Access Compliance Report

Public Rights-of-Way

(Pedestrian Signals)

Intersection ID: N/A	Main Street:	Cross Street: N/A	Location: N/A
ADA ID: 219A456E9CB7	Signal Type: One Push Button-Non APS	Overall Compliance: No	Severity Score: BTN 1: N/A BTN 2: N/A No BTN: N/A
Codes/Mitigation Info/Possible Solution		Field Measurements/Component Compliance

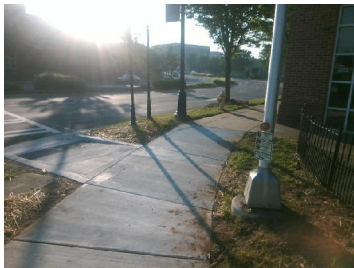
Surveyor Notes: TEXT HT1/2, SIGNAL NOT FUNCTIONING WHEN PRESSED

PROW/ADA: R410.6, TMUTCD 4e.08, R406.2, R404.7.3, R403.4

Possible Solutions: Replace Signal Push Button With APS Button on New Post. Remove & Replace Sign.
